# Church Road Safety and Mobility Improvements

## Lauderdale Drive to John Rolfe Parkway

### Public Feedback Summary

### Public's Preference - Option 3: Dual Bike Lanes with Median

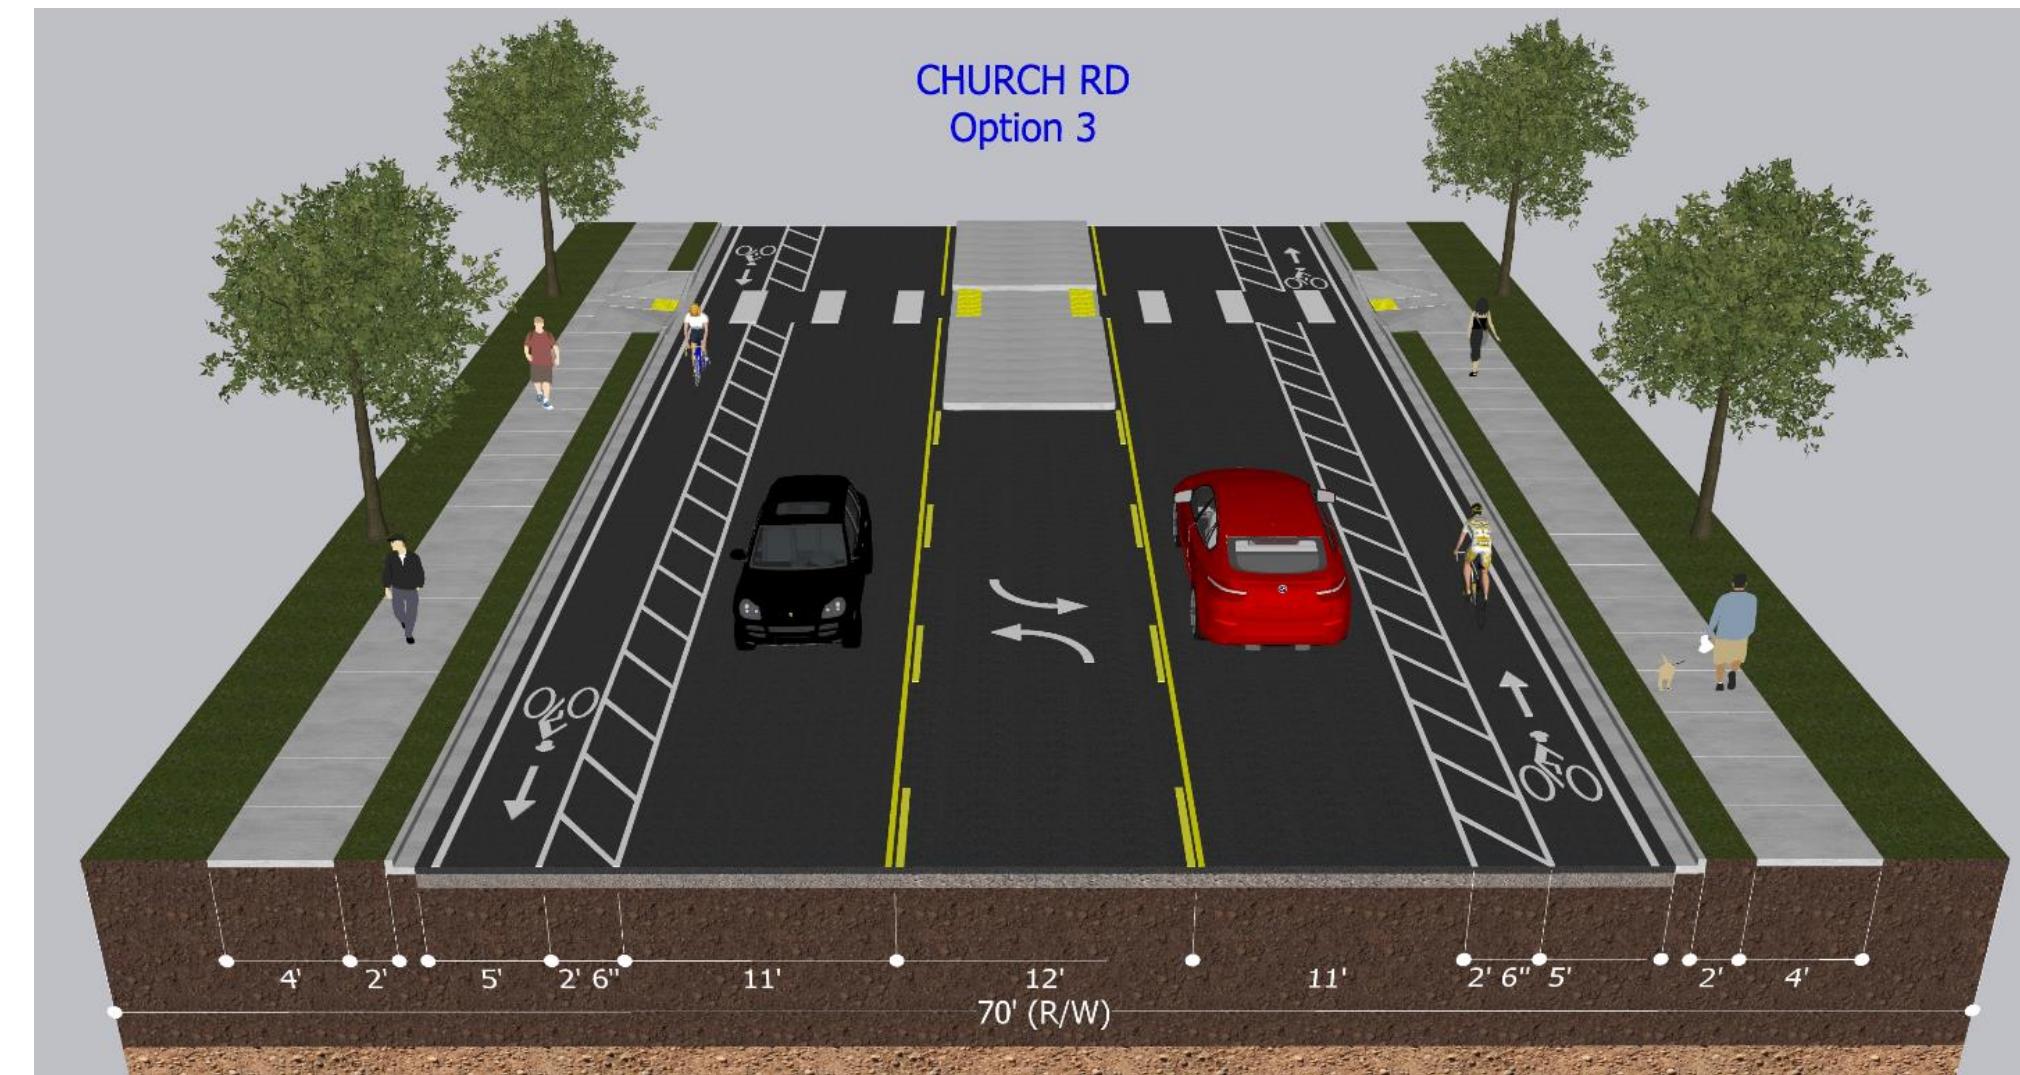
Option 1	Dual Bike Lanes – 2 Vehicular Lanes and 8-ft Bike Lanes with 5-ft Buffer	9% Supported
Option 2	Cycle Track – 3 Vehicular Lanes and 12-ft, 2-Way Cycle Track with Painted Buffer	22% Supported
Option 3	Dual Bike Lanes with Median	71% Supported

The feedback on Option 3 documented that the preference for the option was mainly since it was best balanced and provided safety for all users, including vehicles, bicyclists, and pedestrians. The respondents found that the bicycle lanes were less confusing than the cycle track shown in Option 2, as they felt that bicycle lanes should be in the same direction as traffic. The respondents also liked that Option 3 provided refuge for pedestrians in the crosswalks and that it provided turn lanes that were desired to avoid backups.

Next steps will include refining the preferred concept and showing how to tie the bicycle lanes into the adjacent neighborhoods. If there is additional input, please contact Sharon Smidler at [smi20@henrico.us](mailto:smi20@henrico.us).
